# HISTORIC AND DESIGN REVIEW COMMISSION

May 17, 2017

**HDRC CASE NO:** 2017-225  
**ADDRESS:** 1127 S ST MARYS  
**LEGAL DESCRIPTION:** NCB 2963 BLK LOT E 97.33 FEET OF A-21  
**ZONING:** C-2 IDZ H  
**CITY COUNCIL DIST.:** 1  
**DISTRICT:** King William Historic District  
**APPLICANT:** Jim Poteet/Poteet Architects  
**OWNER:** Stacey Hill  
**TYPE OF WORK:** Removal of existing concrete paving and the installation of a circular decomposed granite driveway

# **SITE PLAN:** 1127 S ST MARYS ST

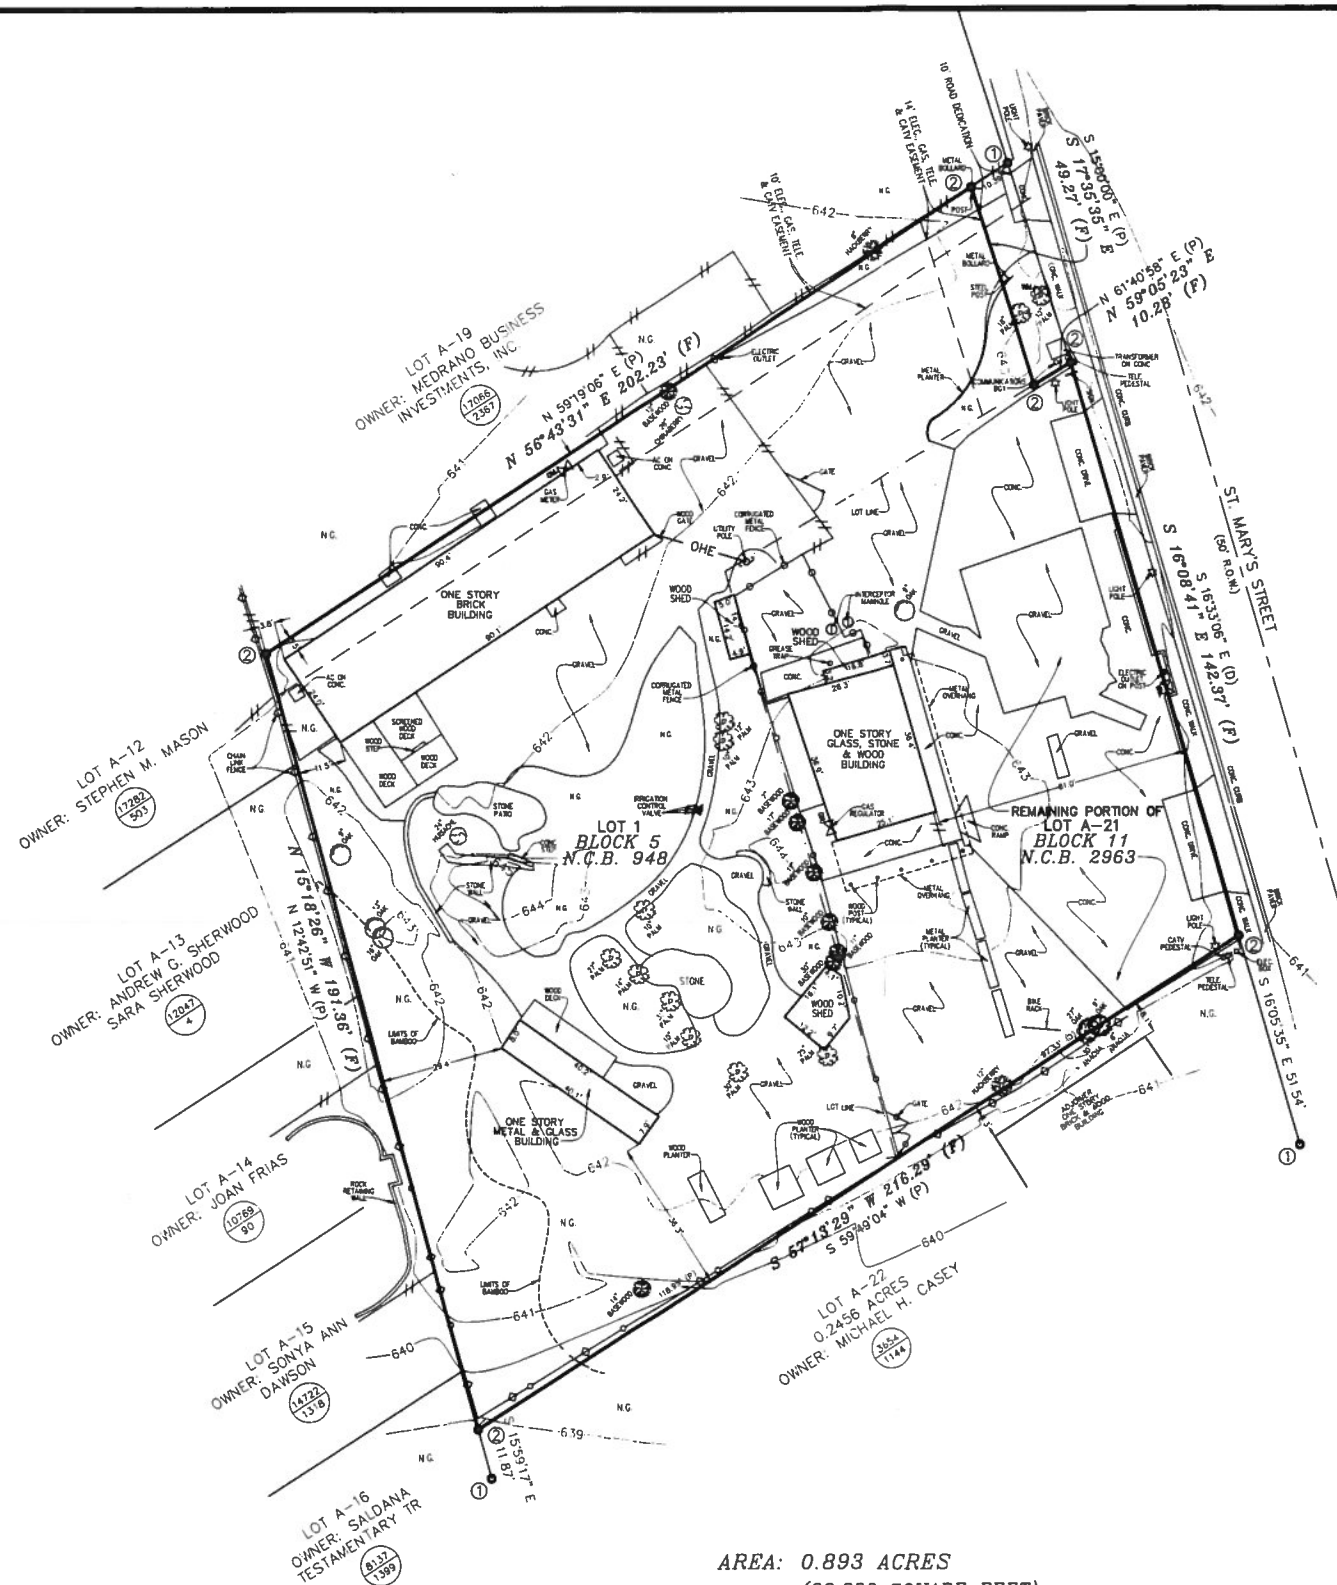
- c. DRIVEWAY – Per the Guidelines for Site Elements 5.B., driveways and curb cuts should be similar to those found historically throughout the district. Curb cuts and driveway configurations vary along S St Mary's. Staff finds the installation of a circular driveway of decomposed granite a reduction in the previous impervious cover and appropriate.

- d. LANDSCAPING – The applicant has noted the installation of landscaping in other areas of the lot where the proposed driveway is not located. The applicant is to provide a detailed list of landscaping items and a landscaping plan to staff prior to receiving a Certificate of Appropriateness.

Staff recommends approval based on findings a through d with the stipulation that the applicant provide staff with a detailed list of landscaping items and a landscaping plan prior to receiving a Certificate of Appropriateness.
